DEPARTMENT OF COMMUNITY AND ECONOMIC DEVELOPMENT

A. REPORT TO THE HEARING EXAMINER		
HEARING DATE:	August 9, 2016	
Project Name:	Elliott Farms Preliminary Plat	
Owners:	Lennon Investments, Inc., 35815 SE David Powell Road, Fall City, WA 98024 Cedar River Lightfoot, Inc., 14410 Bel-Red Road, Suite 200, Bellevue, WA 98007	
Applicants:	Patrick O. Lennon, 35815 SE David Powell Road, Fall City, WA 98024 Todd Levitt, 14410 Bel-Red Road, Suite 200, Bellevue, WA 98007	
Contact:	Ivana Halvorsen, Barghausen Consulting Engineers, Inc. 18215 - 72nd Ave S, Kent, WA 98032	
File Number:	LUA15-000242, ECF, PP, SA-H, MOD	
Project Manager:	Clark H. Close, Senior Planner	
Project Summary:	The applicant is requesting Preliminary Plat, Hearing Examiner Site Plan Review, SEPA Environmental Review, and a Street Modification for a 45-lot subdivision for the future construction of attached two- and three-unit buildings. The 6.07-acre site is located along SR-169 between 140th Way SE and 145th Ave SE within the Residential-14 zoning district (APN 2223059004). The subdivision of 45 residential lots and 8 tracts would result in a net density of 9.7 dwelling units per acre. The tracts include 47,911 sf of cri

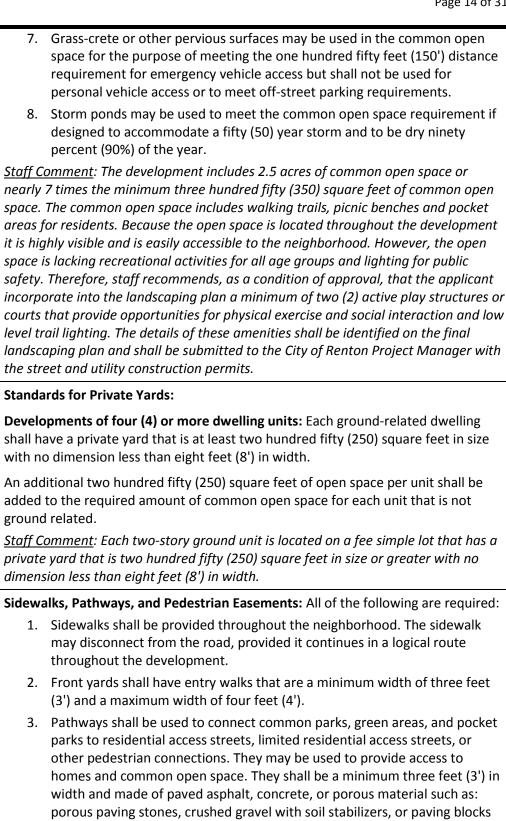
3. The garage shall not exceed forty four feet (44') in width, and shall maintain an eight foot (8') separation from any dwellings.		
	Staff Comment: The preliminary floor plans and elevations include a garage setback of at least eight feet (8') from the front porch. Each unit has garage space assigned and attached to the unit and the garage designs are also similar in design to the homes. Compliance for this standard would be further verified at the time of building permit review.		
	Standards for Parks: For developments that are less than ten (10) net acres: No park is required, but is allowed.		
N/A	For developments that are greater than ten (10) net acres: A minimum of one one-half (.5) acre park, in addition to the common open space requirement, is required.		
	<u>Staff Comment</u> : The development is less than ten (10) net acres, so no park is required. Although open space, walking trails, and park amenities have been provided by the development.
